Subject: Sequoyah Fuels Corporation, Docket – 40-8027
Response to OIs on the Final Safety Evaluation Report –
Reclamation Plan (TAC L52511)

**Sequoyah Fuels Corporation
Draft Safety Evaluation Report (DSER)
Remaining Open Issues as of September 2006**

FIGURE 1
EROSION PROTECTION FACILITIES AT TOP OF STREAM 005 DRAINAGE

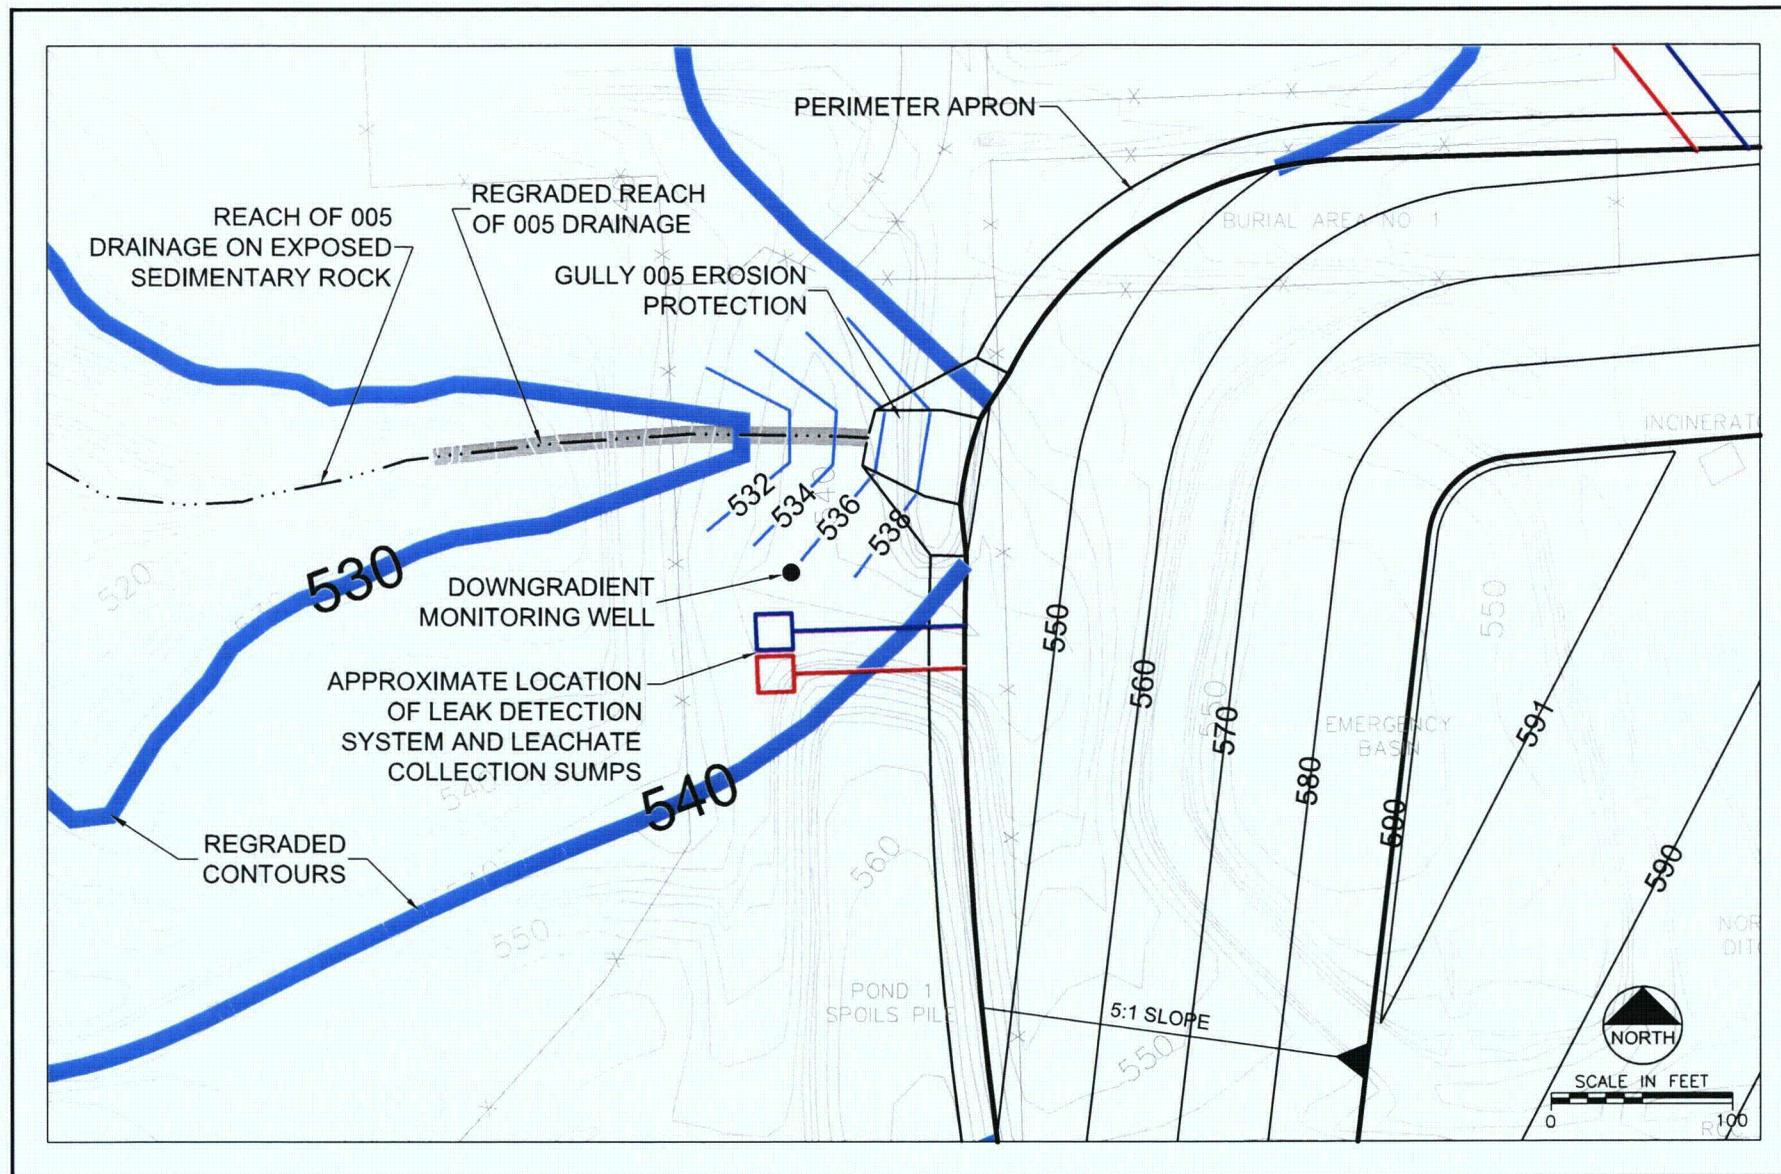
The licensee needs to provide a design for rock armor protection of stream 005, and clarification of the bed slope and depth to sedimentary rock along the 005 drainage.

The rock armor protection at the 005 drainage has been enlarged, based on discussions with NRC. The updated rock armor protection layout is shown in Figure 1. Figure 2 provides a plan and profile along the 005 drainage, showing depth to sedimentary rock (from available drill hole information and surface reconnaissance) and planned excavation at the toe of the disposal cell.

The rock apron on the west side of the disposal cell has been enlarged to provide protection in the unlikely event of headward erosion from Stream 005. The rock apron is a downstream extension of the perimeter apron at the toe of the disposal cell slopes and is located where runoff from the west slope of the disposal cell discharges into the east end of the 005 drainage. The rock apron will be constructed with the perimeter apron rock and keyed into underlying shale.

FIGURE 3
PARTICLE-SIZE DISTRIBUTIONS OF EROSION PROTECTION AND
BEDDING MATERIALS

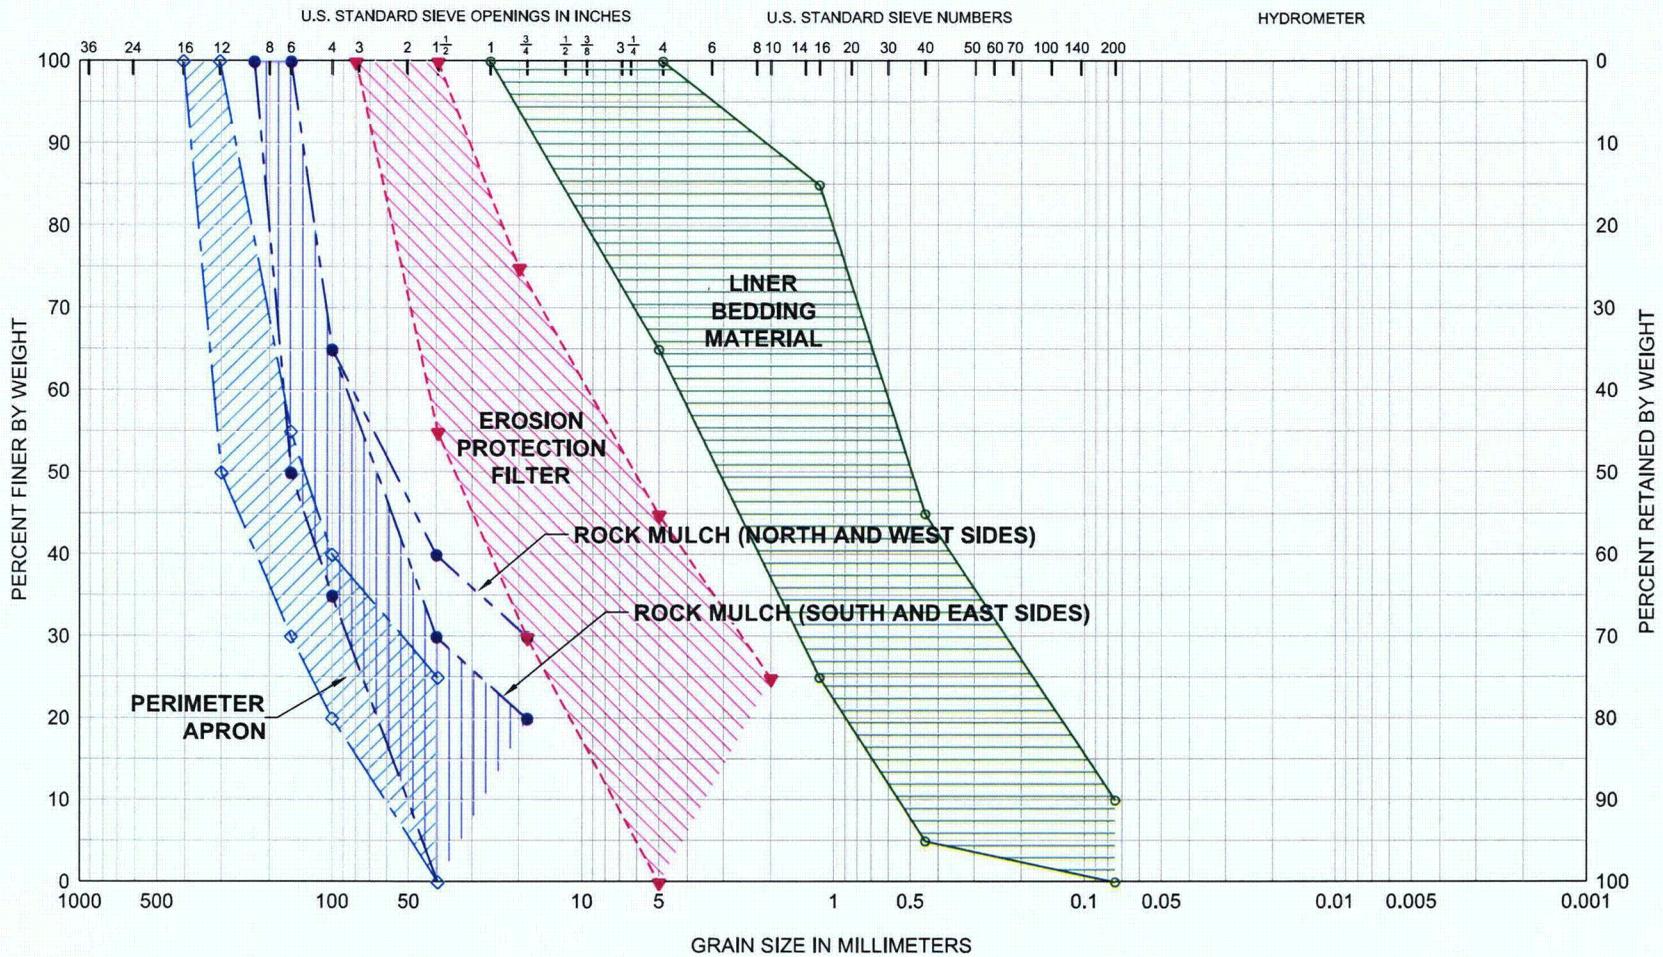
The licensee needs to clarify the specifications for riprap rock gradation for three issues: (1) the gradation requirements are not stringent enough ensure that the required median particle size (D_{50}) can be achieved; (2) the gradation requirements should be adjusted to reflect placement of erosion protection rock only (with fines addition as a second step); and (3) the gradation requirements should be based on use of angular material only (if the licensee is sure that the nearby limestone quarry will be the only material source). The licensee may also adjust the gradation requirements of the erosion protection rock on the various side slopes of the disposal cell, since all of the side slope material has been sized for the most conservative flow case.

The gradation for the rock portion of the rock mulch layer has been limited to angular rock (since the licensee has selected a limestone quarry as the preferred riprap source), and has been separated by individual side slope (due to the difference in catchment area and design storm runoff). The north and west slopes of the disposal cell will have runoff from precipitation on the side slopes only. The calculated median (D₅₀) rock size of north and west slope rock is 2.7 inches. The south and east slopes of the disposal cell will have runoff from precipitation on the top and side slopes, with a calculated median rock size of 3.4 inches. The proposed modification to Section 7.2.5 of the Technical Specifications (Reclamation Plan Attachment A) to reflect the adjustments described above are outlined below.

<u>South and East Slopes</u>	<u>North and West Slopes</u>
<u>Sieve Size</u>	<u>Percent Passing</u>	<u>Percent Passing</u>
9 inch	100	100
6 inch	50-100	50-100
4 inch	35-65	35-65
1.5 inch	0-30	0-40
¾ inch	0-20	0-30

The gradation for perimeter apron material has been modified to be more closely aligned with the median rock size (6.8 inches for angular rock from a nearby limestone quarry). Because the calculated median size of perimeter apron material does not vary significantly among side of the cell, one gradation is planned for all of the perimeter apron material. The proposed modification to Section 7.2.6 of the Technical Specifications (Reclamation Plan Attachment A) to reflect this gradation adjustment is outlined below.

<u>Sieve Size</u>	<u>Percent Passing</u>
16 inch	100
12 inch	50-100
6 inch	30-55
4 inch	20-40
1 ½ inch	0-25

The gradations for the rock portion of the rock mulch and perimeter apron materials are shown in Figure 3.
